ENGINEERING CHANGE ORDER

PART NO. **1234-5678**

CHANGE NO. **P675**

REVISION **D**

SHEET
2 OF 4

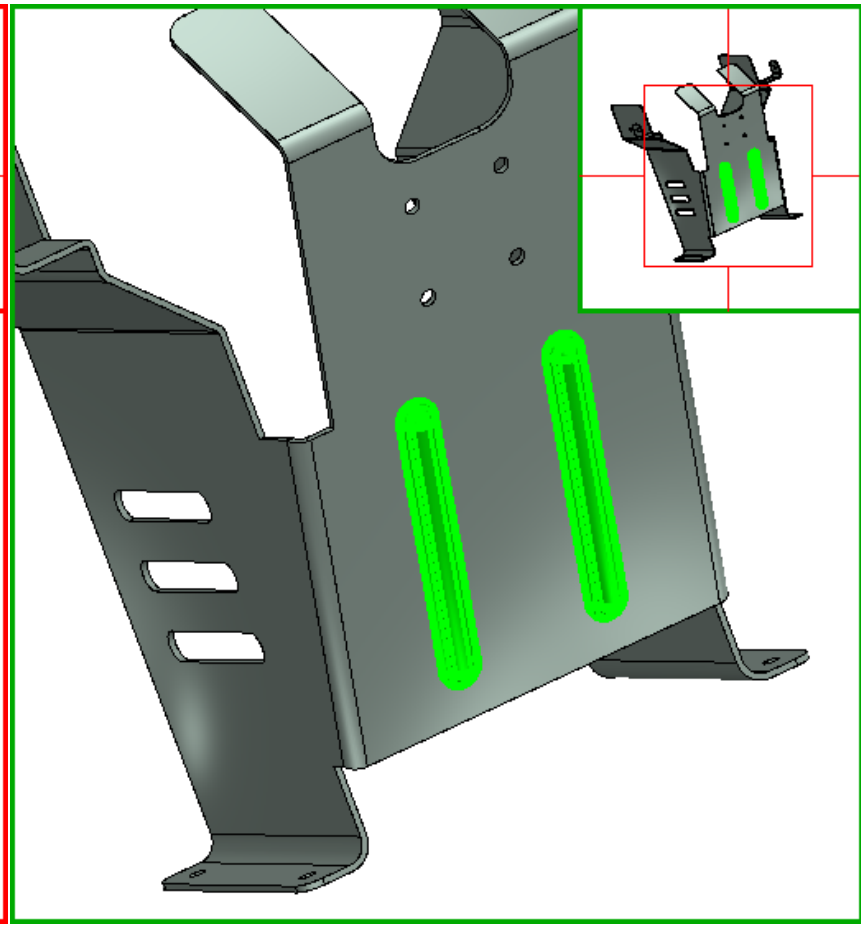
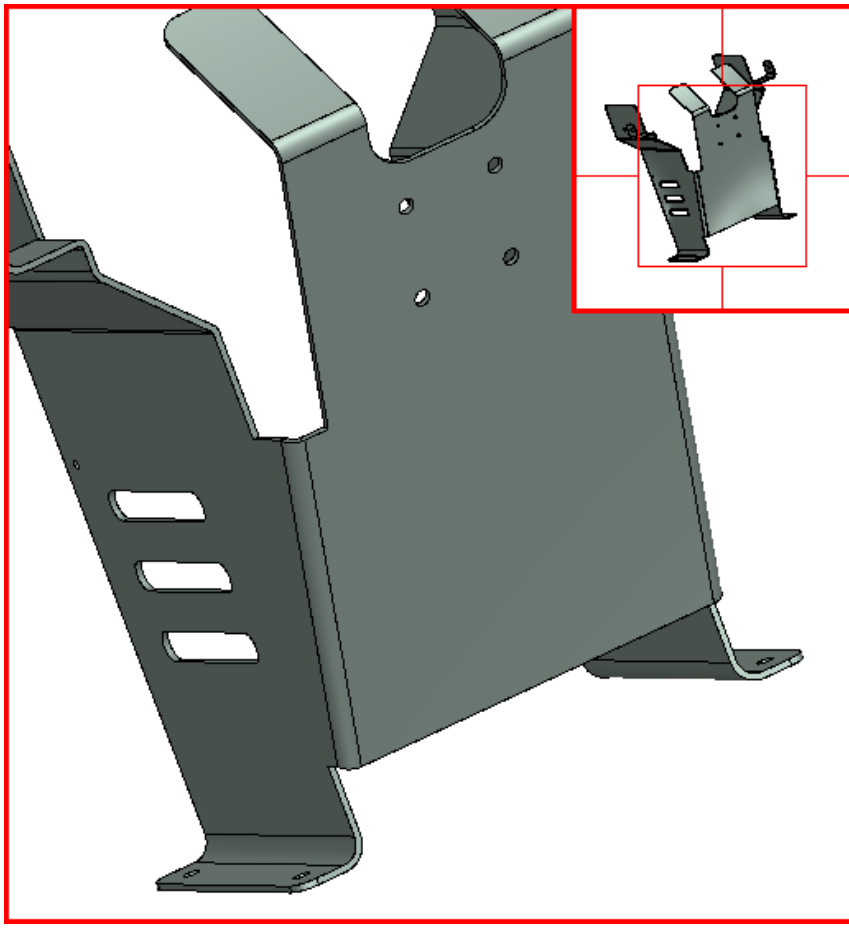
Bead ribs added for strength

SHEET
3 OF 4

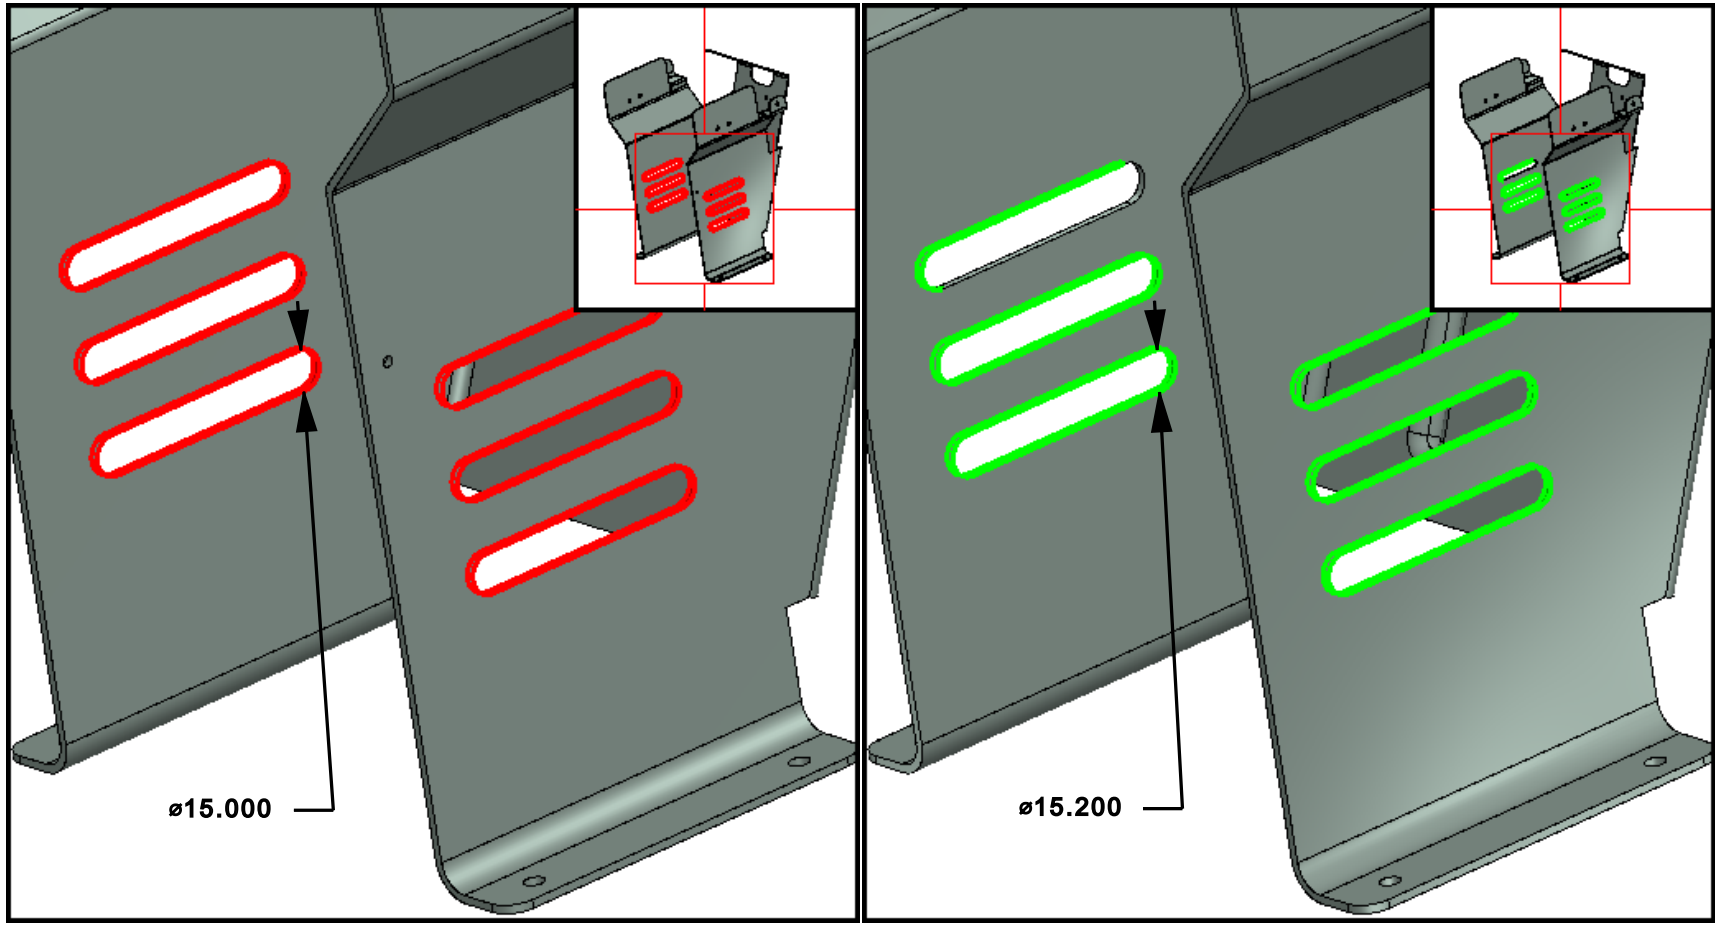
Slots enlarged for additional clearance
